Model

I12 (i8 Coupe)

I15 (i8 Roadster)

The drivability/steering behavior appears inconsistent.

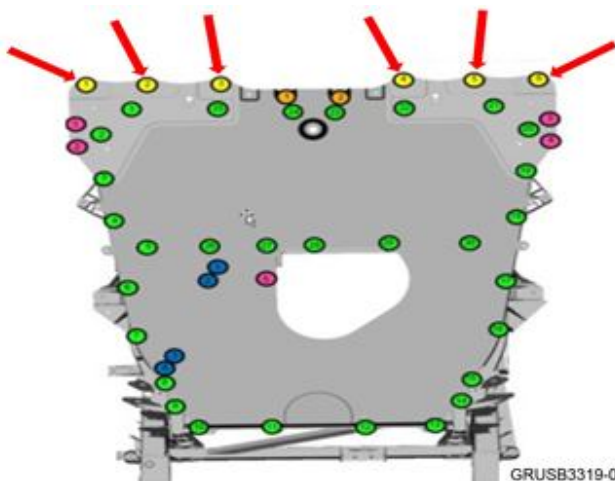
Rear axle stiffening plate.

Re-torque the rear axle stiffening plate bolts.

3. With the vehicle on an alignment rack so that the vehicle is resting on all four (4) wheels, retighten the 30 M8 bolts (shown in green) for the stiffening plate on the rear axle module.

- Loosen each bolt (shown in green) by approx. 45 degrees, then retighten with 28 Nm
- Do not proceed to the next bolt until the previous one has been torqued

Note: The 30 M8 ISA bolts **DO NOT HAVE WASHERS.**

4. Replace the 6 M10 Torx bolts as shown (red arrows) and tighten them with 56 Nm + 90°.
